**PROPOSAL, SPECIFICATIONS, BOND AND AFFIDAVIT FOR THE CONSTRUCTION OF  
WALNUT STORM WATER CAPTURE AND GROUNDWATER REPLENISHMENT BASIN, I-173  
B2019-37**

**ADDENDUM NO. 1**

**Issued: August 15, 2019**

**PROPOSAL, SPECIFICATIONS, BOND AND  
AFFIDAVIT FOR THE CONSTRUCTION  
OF  
WALNUT STORM WATER CAPTURE AND GROUNDWATER  
REPLENISHMENT BASIN, I-173  
B2019-37**

SITE PLAN

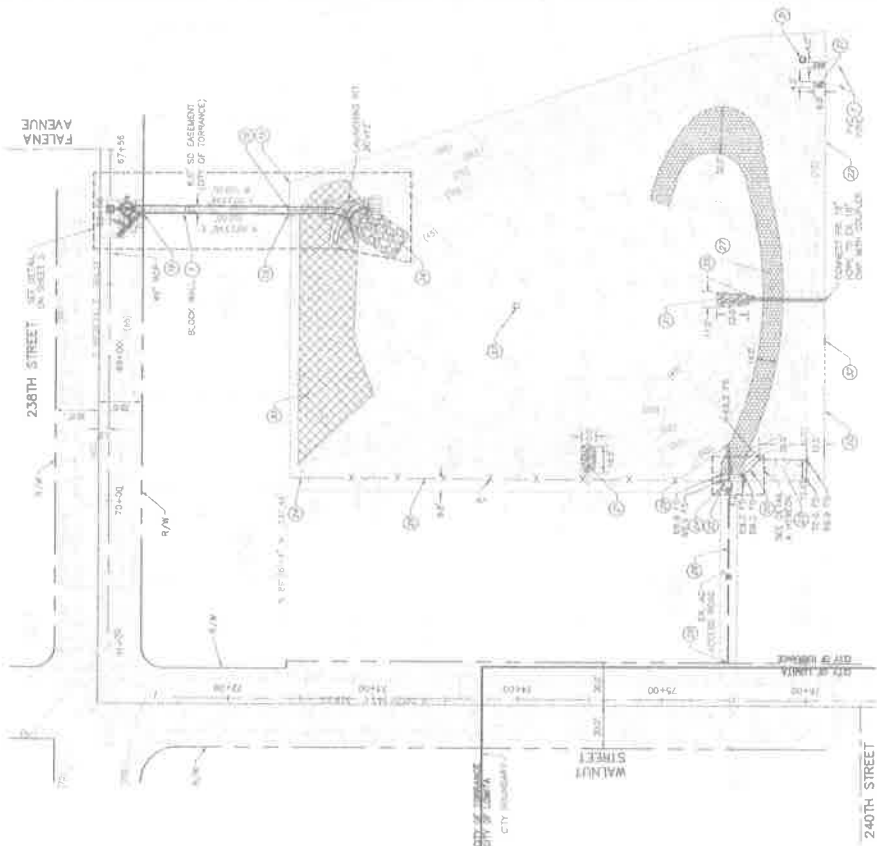
SD-512 Plan Sheets, Sheet 4 of 9 is hereby deleted in its entirety and replaced with Sheet 4 of 9 Revision 1, where the split rail fence material was changed to Western Red Cedar and staff gauge height updated to 15 feet and is attached to this Addendum.

NO.	DATE	BY	REVISIONS
1	12/31/20	S.B.	CHANGED STAFF GAUGE HEIGHT AND WEATHER SITE TOTAL
REVISED TOTAL

PROJECT: WALNUT STORM WATER CAPTURE AND GROUNDWATER REPLENISHMENT BASIN, I-173  
 SHEET: STORM DRAIN PLAN AND PROFILE

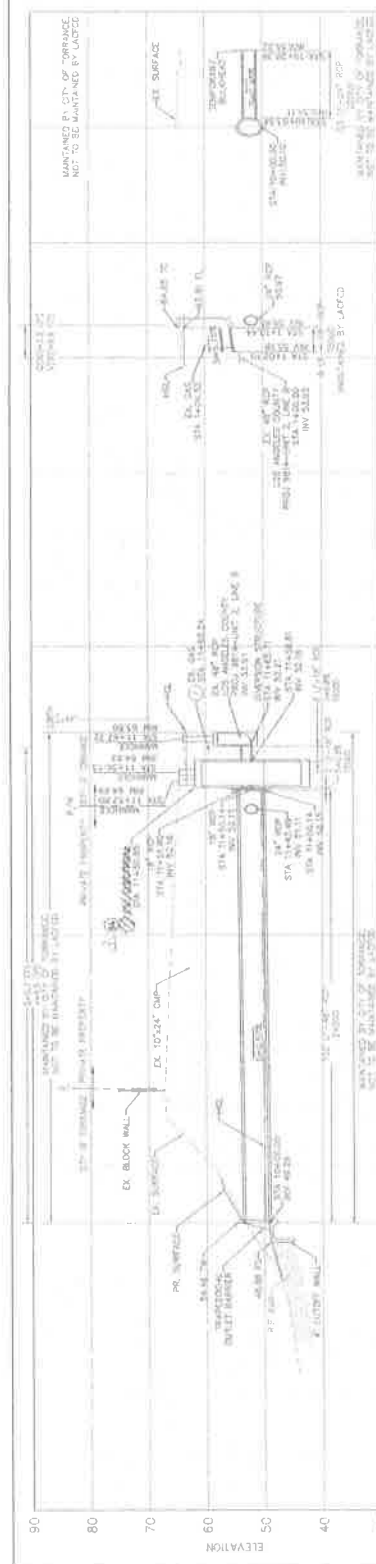
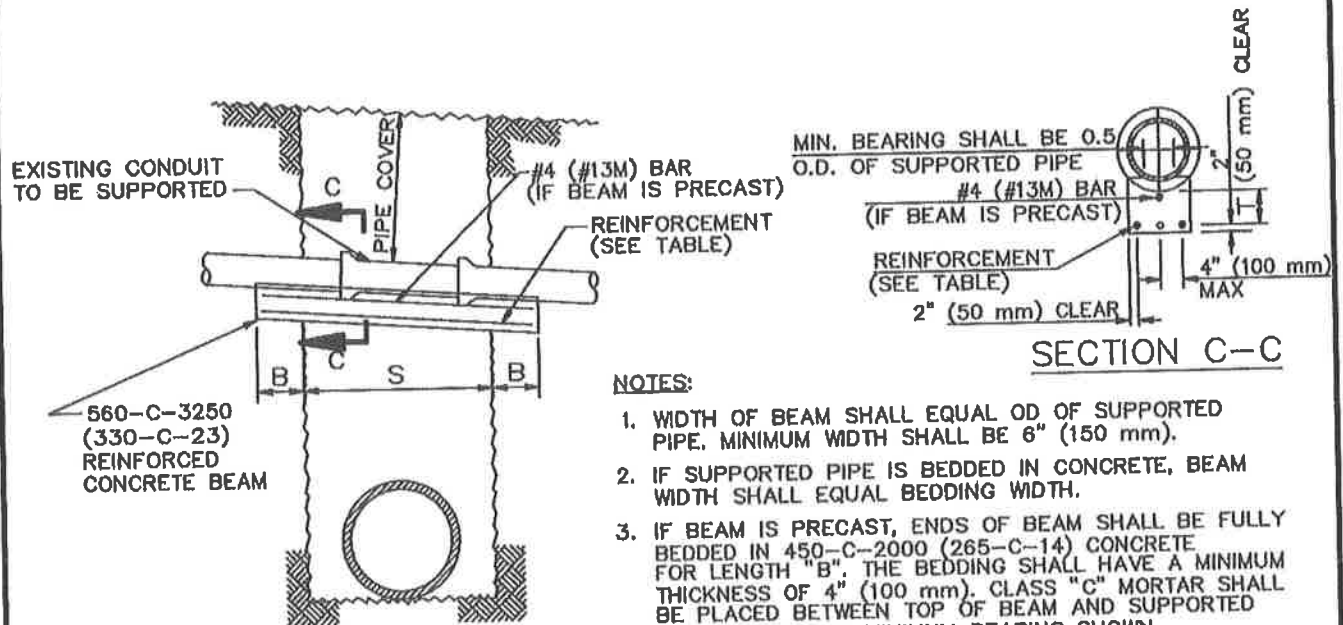
SD-512 Plan Sheets, Sheet 5 of 9 is hereby deleted in its entirety and replaced with Sheet 5 of 9 Revision 1, which added note 54 remove abandoned utility line and is attached to this Addendum.
